LOT GRADING REVIEW

LECCO RIDGE DEVELOPMENTS INC.

PROJ. No. 16-12 MUNICIPAL ADDRESS

LOT No. 124

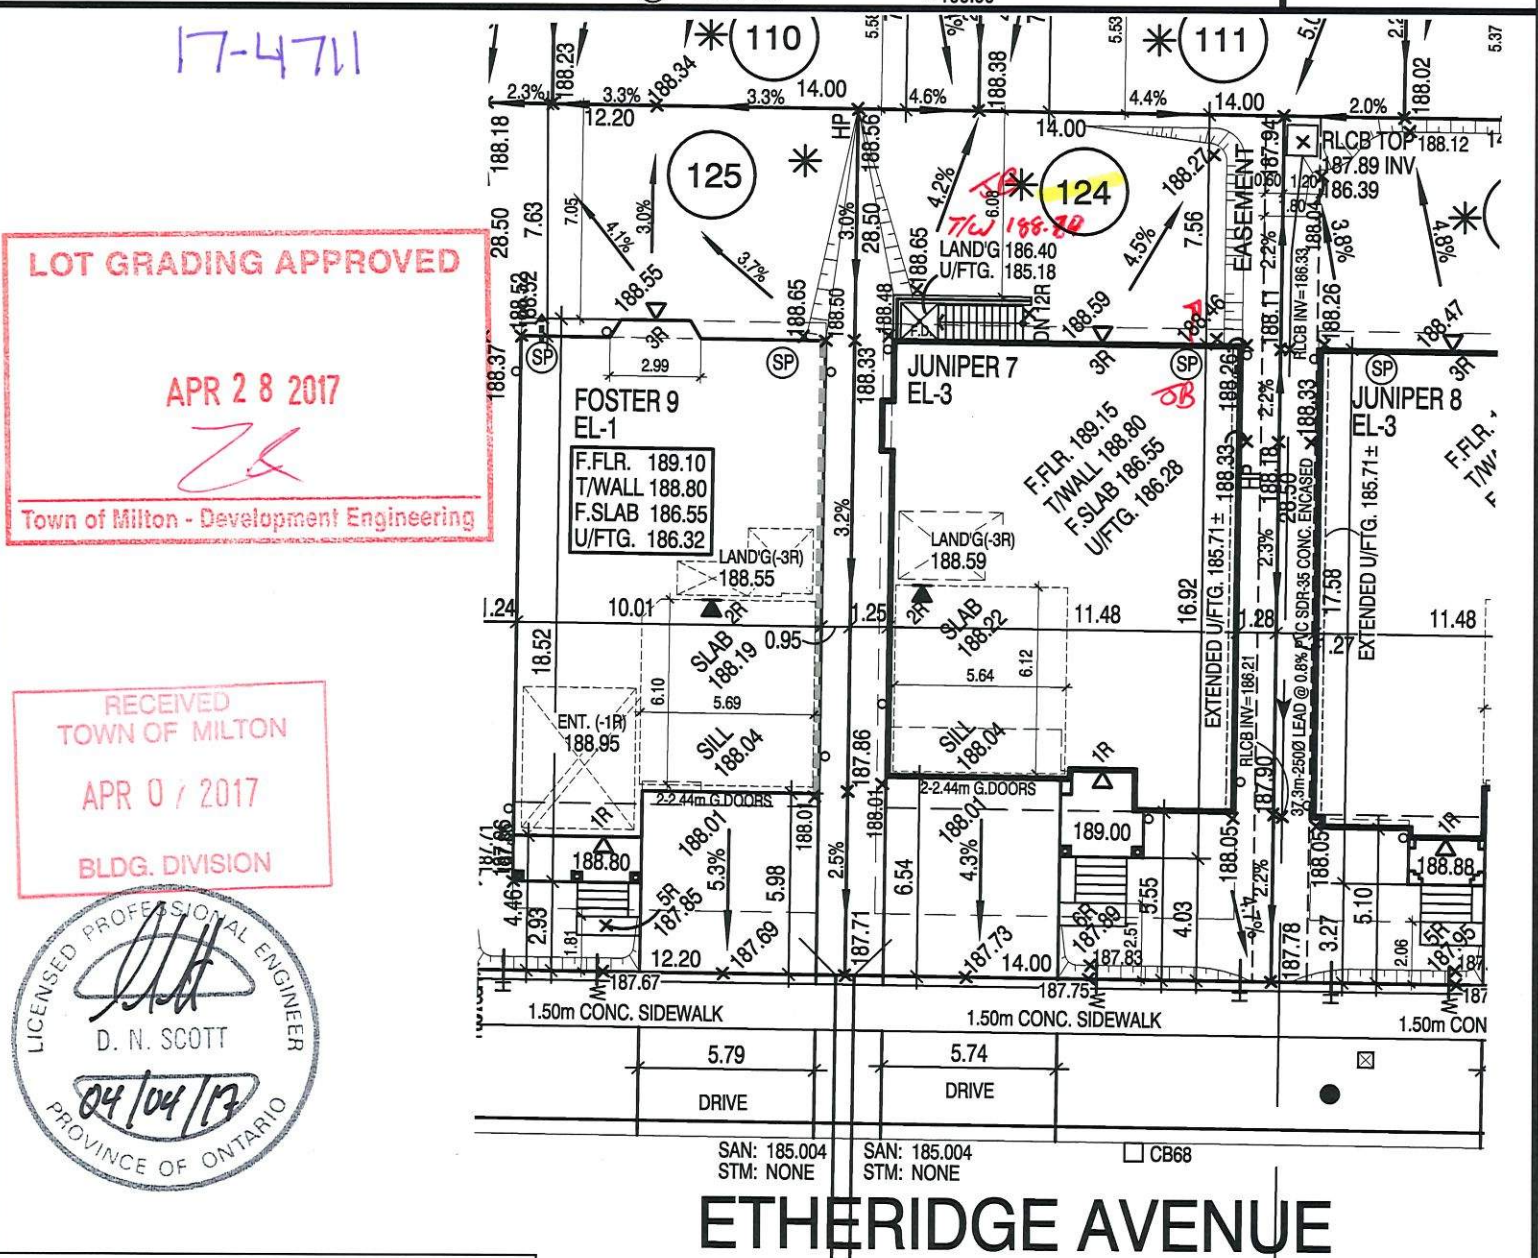
45 Min FRR

45 Min FRR w/NC Cladding

Guard/Handrail as per 9.8.

Backfill height as per 9.15.

Siting to be read in conjunction with reviewed main model drawings

SUMP PUMP TO DISCHARGE TO REAR SPLASH PAD.

45 MINUTE RATED WALL WITH SIDE YARD < 1.2m
